Access Compliance Report

Public Rights-of-Way

(Curb Ramps)

Intersection ID: 14620	Main Street: EUCLID_AV	Cross Street: MCDONALD_AV	Location: N
ADA ID: 6078E06CD47E	Ramp Type: Directional1	Initial Pass/Fail: Fail	Overall Compliance: No
Codes/Mitigation Info/Possible Solution		Field Measurements/Component Compliance	
Severity Score: 26.25

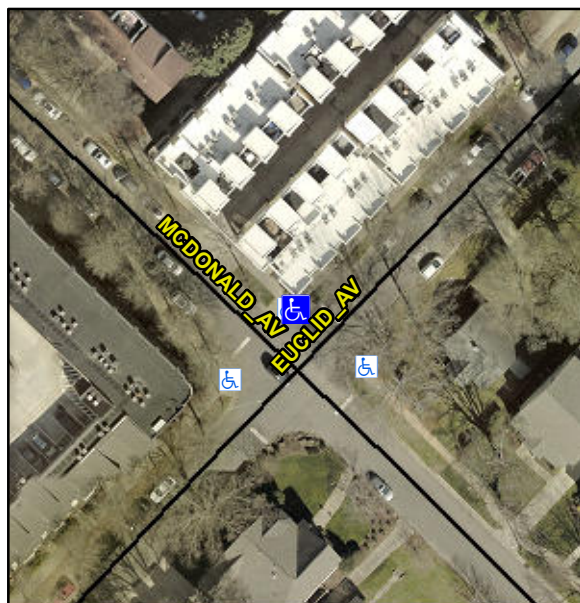
Remove & Replace Entire Ramp.

R304.2.2, R304.5.3
